FIRE SAFETY FOLLOW UP INSPECTION

Factory Name	A.K.M. KNIT WEAR LTD.		Accord ID	9178
Address	14 No. Genda, Karnopara, Ulail, Savar			
Inspection Date	24/03/2014		Report Received Date	21/09/2014
Date of 1st Follow-up	13/02/2015	Date of 2nd Follow-up	17/01/2016	
Date of 3rd Follow-up	09/05/2016	Date of 4th Follow-up	28/07/2016	
Date of 5th Follow-up	16/11/2016	Date of 6th Follow-up	24/01/2017	
Date of 7th Follow-up	23/04/2017	Date of 8th Follow-up	23/08/2017	
Date of 9th Follow-up	31/01/2018	Date of 10th Follow-up	27/06/2018	
Date of 11th Follow-up	17/02/2019

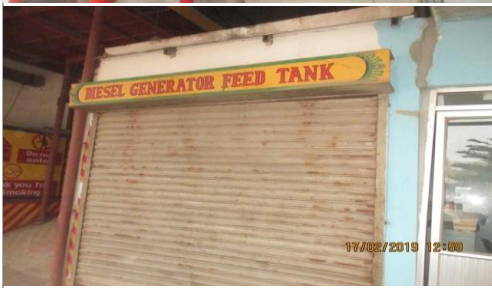
31	Manual on-off switches in several locations are provided for emergency lighting / exit signage units.	Remove manual on/off switches from emergency lighting / exit signage units to prevent them from being switched off.	Within 1 month	On 23/04/2017: Corrected. On 23/08/2017: Corrected. On 31/01/2018: Corrected On 27/06/2018: Corrected. On 17/02/2019: Corrected based on previous follow ups.	'30/12/2014	Done	Corrected	ADD PHOTO
32	Exit sign not provided at the southwest exits.	Provide exit signs above all exits to the exterior and all doors to the exit stairs.	Within 3 months	On 23/04/2017: Corrected. On 23/08/2017: Corrected. On 31/01/2018: Corrected On 27/06/2018: Corrected. On 17/02/2019: Corrected based on previous follow ups.	'30/12/2014	Done	Corrected	ADD PHOTO
33	Hazardous materials / flammable liquid storage area in the ground floor and ground is not separated by fire-rated	Separate the hazardous materials / flammable liquid storage room by a minimum 2-hr fire-rated construction. Seal and or protected all openings in the required fire separations.	Within 3 months	On 23/04/2017: Corrected. On 23/08/2017: Corrected. On 31/01/2018: Corrected On 27/06/2018: Corrected. On 17/02/2019: Refer to issue 54.	'30/12/2014	This issue is corrected. (Done)	Corrected	ADD PHOTO
